KID BOTTLE

350cc

Print Area

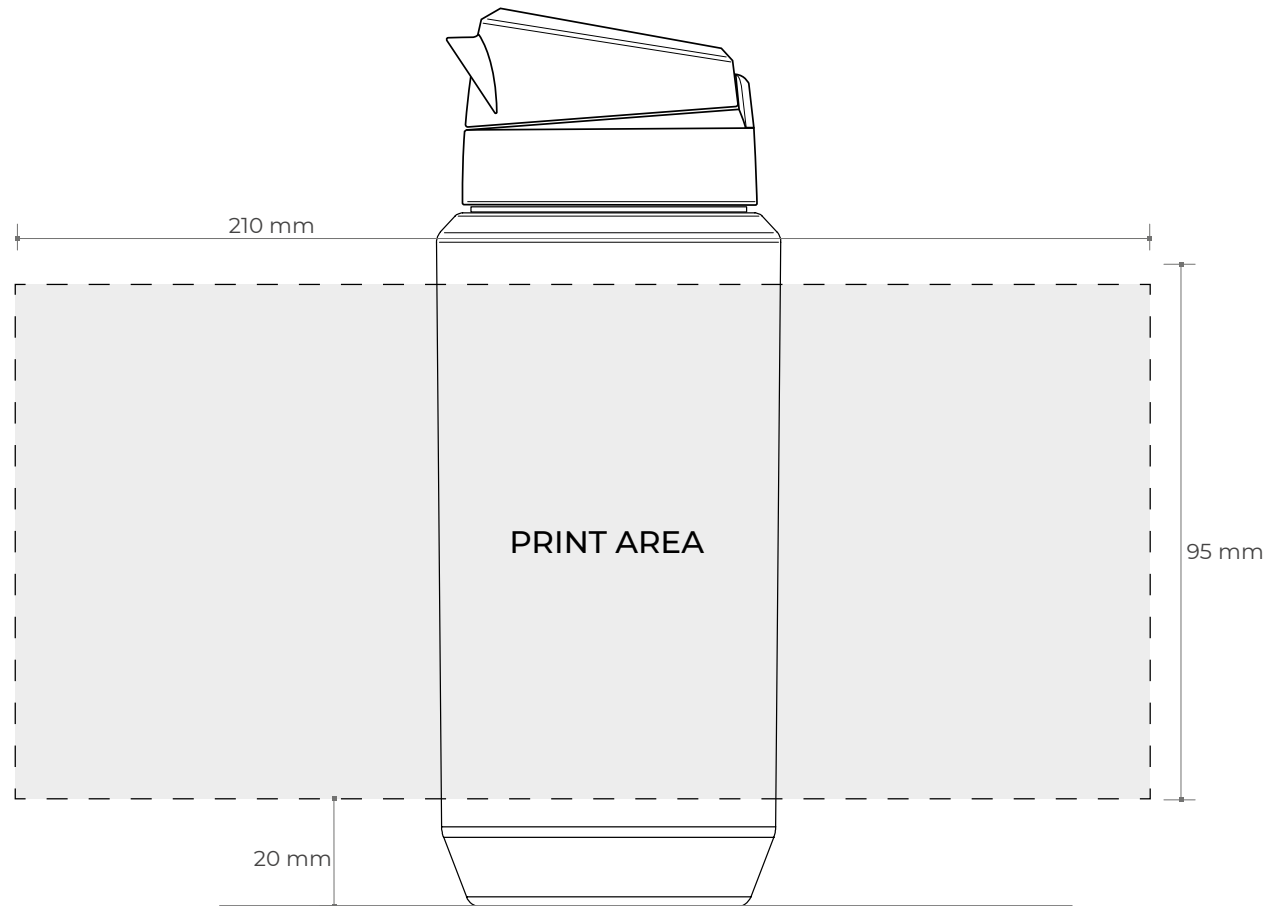
*The impression can not close on the circumference of the bottle:
it's necessary to consider a non-printable area (approx. 0,8 cm width)*
